**PRAIRIE ISLAND NUCLEAR GENERATING PLANT
DOCKETS 50-282 AND 50-306
LICENSE NOS. DPR-42 AND DPR-60
PRAIRIE ISLAND EMERGENCY PLAN IMPLEMENTING PROCEDURES**

F3-2 Classifications of Emergencies

Summary of EAL Changes

F3	CLASSIFICATIONS OF EMERGENCIES	NUMBER: F3-2
		REV: 34

(EAL Ref Manual 1B)

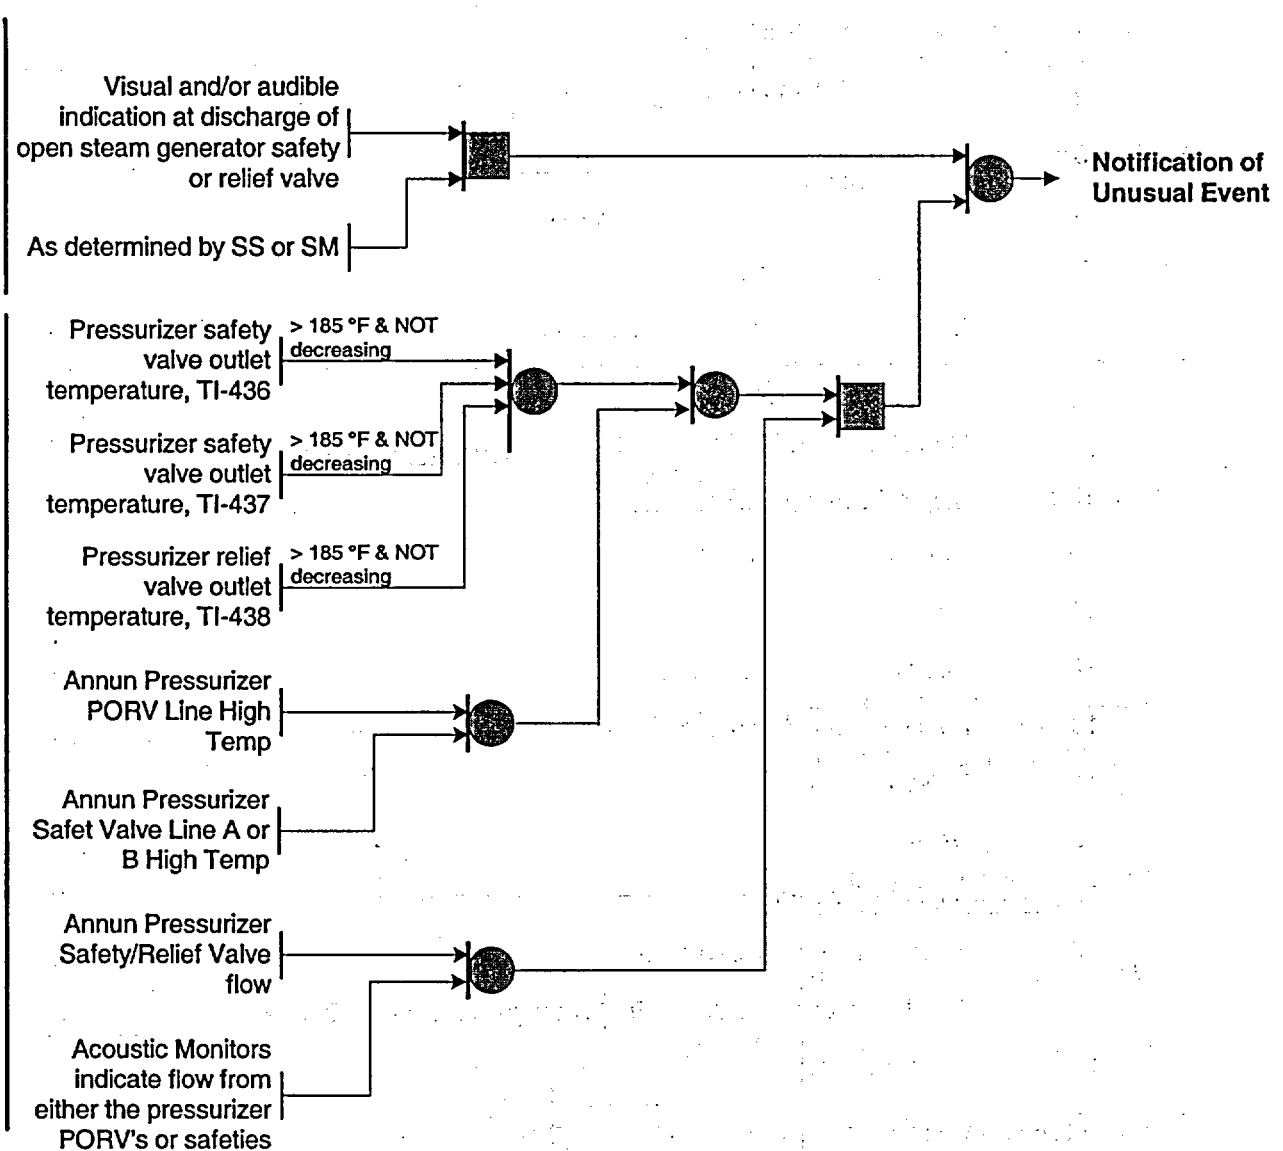
EAL Reference Number	Description of differences between F3-2 Rev. 33 and F3-2 Rev. 34
1B	<p>Changes:</p> <ol style="list-style-type: none"> 1. Removed "Pressurizer Pressure (2/3) < 2335". 2. Added "Pressurizer PORV Line High temp", "Pressurizer Safety Line A or B High temp", and "Pressurizer Safety/Relief valve flow" annunciators. 3. Removed Pressurizer Relief Tank level, temperature and pressure parameters. 4. Acoustic monitors were combined with flow annunciators as an alternative
2A	<p>Changes:</p> <ol style="list-style-type: none"> 1. Removed "Reactor power reduction or cooldown has been initiated" 2. Added new Technical Specification (TS) reference.
2B	<p>Changes:</p> <ol style="list-style-type: none"> 1. Removed mode limitation 2. Removed Shift Supervisor (SS)/Shift Manager (SM)/Emergency Director (ED) opinion
2C	<p>Changes:</p> <ol style="list-style-type: none"> 1. Changed Initiating Condition (shaded box) by adding "(Charging, SI, & RHR)" 2. Removed mode limitation. 3. Added "All available pumps running indicated by the red light(s) at switch" and "No pressurizer level as indicated"

(EAL Ref Manual 2D)

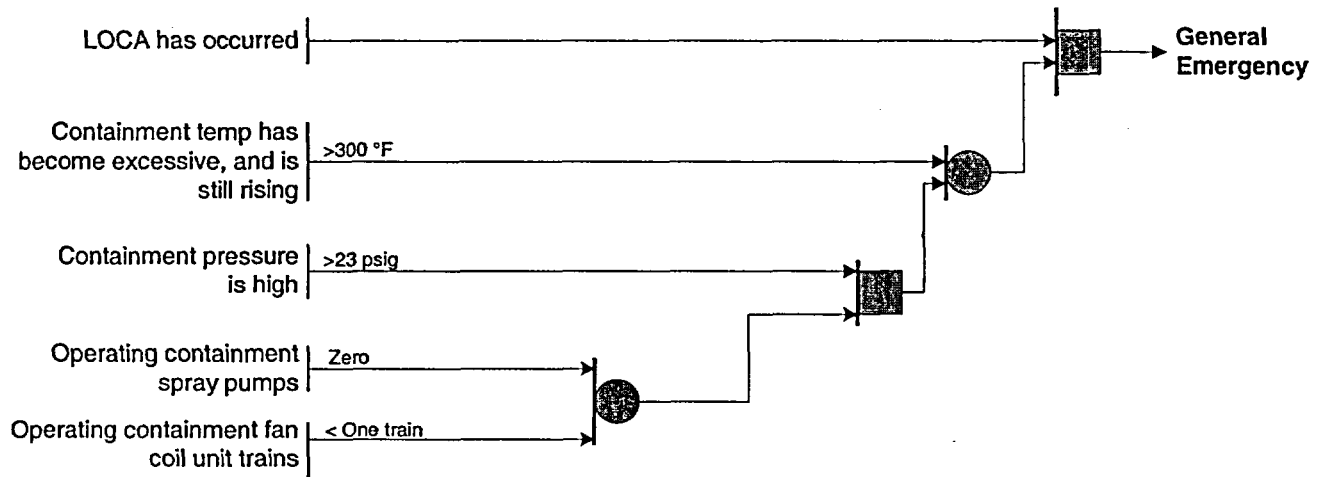
2D	<p>Changes:</p> <ol style="list-style-type: none"> 1. Removed mode limitation 2. Removed SS/SM/ED opinion 3. Revised to say "Containment pressure is high" instead of "high and increasing".
2E	<p>Changes:</p> <ol style="list-style-type: none"> 1. Removed mode limitation. 2. Removed SS/SM/ED opinion. 3. Revised to say "Low subcooling margin" instead of "low subcooling margin and decreasing". 4. Revised from 1000R/hr to 200R/hr for Radiation Monitor R48 or R49.
5C	<p>Changes:</p> <ol style="list-style-type: none"> 1. Added "Inadequate Subcooling (<10 degrees F)"
6 (Cases 1 thru 5)	<p>Changes:</p> <ol style="list-style-type: none"> 1. Removed the mode restriction
6 (Case 1)	<p>Changes:</p> <ol style="list-style-type: none"> 1. Revised from 1000R/hr to 200R/hr for Radiation Monitor R48 or R49.
7A	<p>Changes:</p> <ol style="list-style-type: none"> 1. Changed logic to allow SS opinion to make classification 2. Added "Steam line pressure safety injection signal" 2. Removed "indication of Steam Line Break (SLB) downstream of Main Steam Isolation Valves (MSIV) logic tree"

(EAL Ref Manual 8B)

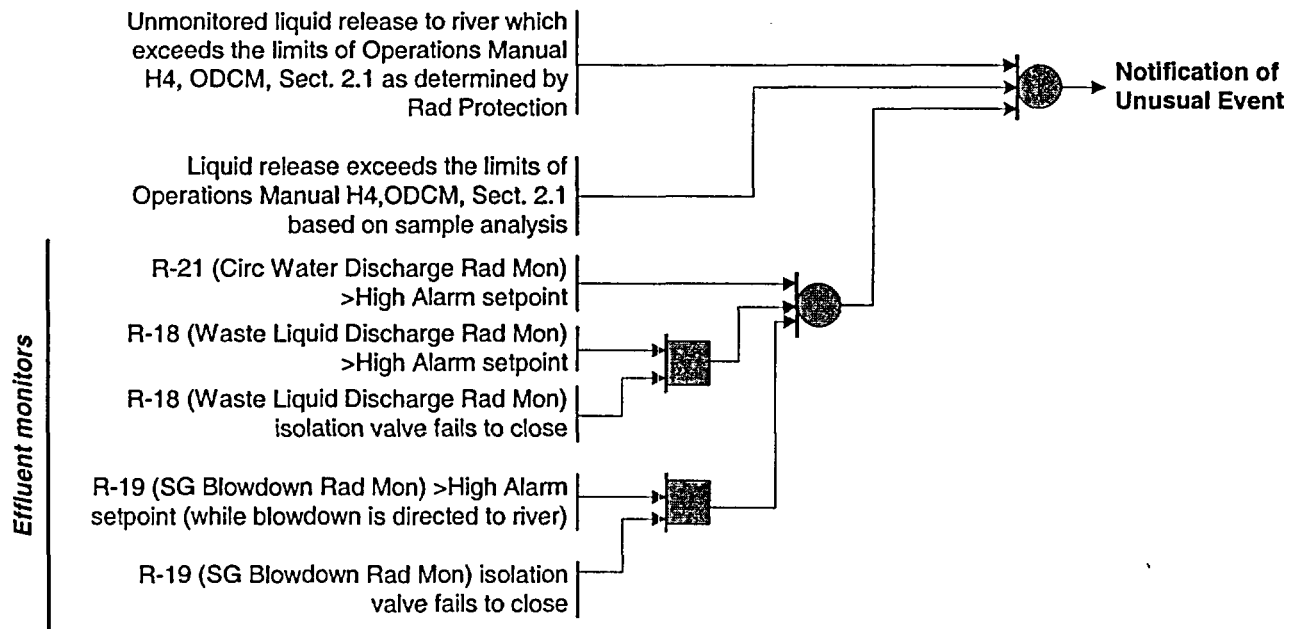
8B	<p>Changes:</p> <ol style="list-style-type: none"> 1. Setup logic such that either a sample or portable or installed monitors exceeding setpoint will require classification.
8D	<p>Changes:</p> <ol style="list-style-type: none"> 1. Changed logic to an 'OR' so that confirmation is not required. Both the installed or portable monitors (R22 and/or R50) are viable methods to determine high radiation
8E	<p>Changes:</p> <p>None</p>
8G	<p>Changes:</p> <ol style="list-style-type: none"> 1. Removed SS/SM/ED opinion
9B	<p>Changes:</p> <ol style="list-style-type: none"> 1. Removed when required by TS
9E	<p>Changes:</p> <ol style="list-style-type: none"> 1. Removed the mode restriction such that this EAL is applicable at all times.
9F	<p>Changes:</p> <ol style="list-style-type: none"> 1. Removed SS opinion.
11A	<p>Changes:</p> <ol style="list-style-type: none"> 1. Added a logic tree that includes a "Fire confirmed within the plant" and adds to an 'OR' box with a logic tree that specifies locations in the plant.

(EAL Ref Manual 12B)

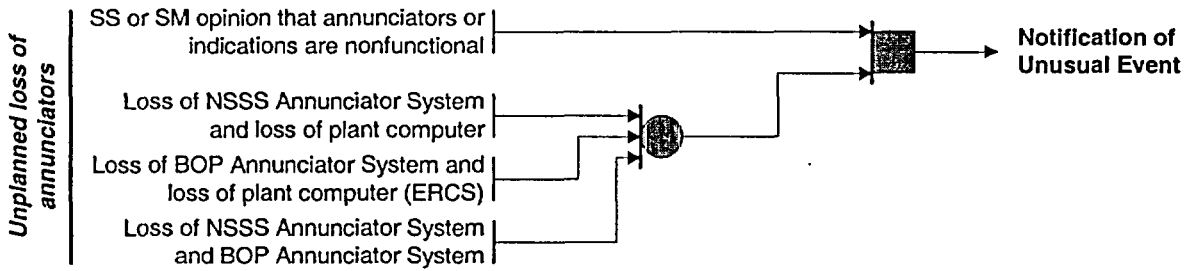
EAL Reference Number	Description of differences between F3-2 Rev. 33 and F3-2 Rev. 34
12B	<p>Changes:</p> <ol style="list-style-type: none"> 1. Revised initiating condition to state "Nonfunctional indications or alarms in the Control Room requiring a plant shutdown" instead of only addressing a loss of alarms in the Control Room. 2. Added to the logic tree "SS or SM opinion that annunciators or indications are nonfunctional"
12C	<p>Changes:</p> <ol style="list-style-type: none"> 1. Removed mode restriction. 2. Removed SS or SM opinion.
12D	<p>Changes:</p> <ol style="list-style-type: none"> 1. Removed the note defining plant transient. 2. Removed the mode restrictions. 3. Removed SS or SM opinion that annunciators are non-functional. 4. Revised the loss of annunciator logic to 'OR' instead of 'AND'
12I	<p>Changes:</p> <ol style="list-style-type: none"> 1. Removed SS opinion.
12J	<p>Changes:</p> <ol style="list-style-type: none"> 1. Removed SS opinion. 2. Added "Reactor or turbine trip due to turbine failure"

(EAL Ref Manual 16A)

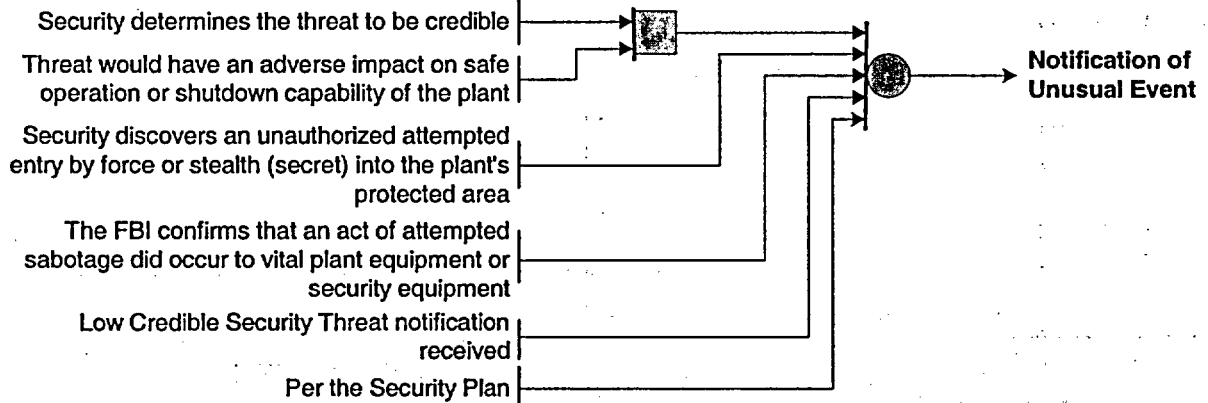
16A	<p>Changes:</p> <ol style="list-style-type: none"> 1. Added "Per the Security Plan"
16B	<p>Changes:</p> <ol style="list-style-type: none"> 1. Added "Per the Security Plan"
16C	<p>Changes:</p> <ol style="list-style-type: none"> 1. Added "Per the Security Plan"
16D	<p>Changes:</p> <ol style="list-style-type: none"> 1. Added "Per the Security Plan"
17A	<p>Changes:</p> <ol style="list-style-type: none"> 1. Eliminated unusual threatening aircraft activity over facility. 2. Changed crash on site to "Visual observation by plant personnel and/or security personnel"
17D	<p>Changes:</p> <ol style="list-style-type: none"> 1. Removed visually observed evidence of an unplanned/unexplained explosion within the owner controlled fence but not affecting plant safe operation. 2. Added "Visual observation by plant personnel and/or security personnel"
17E	<p>Changes:</p> <ol style="list-style-type: none"> 1. Removed visually observed evidence of an unplanned explosion directly affecting plant safe operation. 2. Added "Visual observation by plant personnel" 3. Removed reported to SS or SM

(EAL Ref Manual 19K)

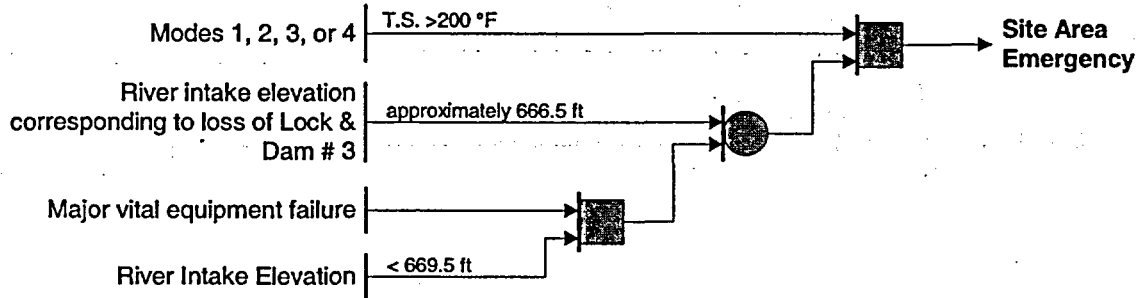
19J	<p>Changes:</p> <ol style="list-style-type: none"> 1. River intake elevation now says "approximately 669.5 ft" rather than <669.5 ft.
19K	<p>Changes:</p> <ol style="list-style-type: none"> 1. Changed <666.5 ft. to "approximately 666.5 ft"
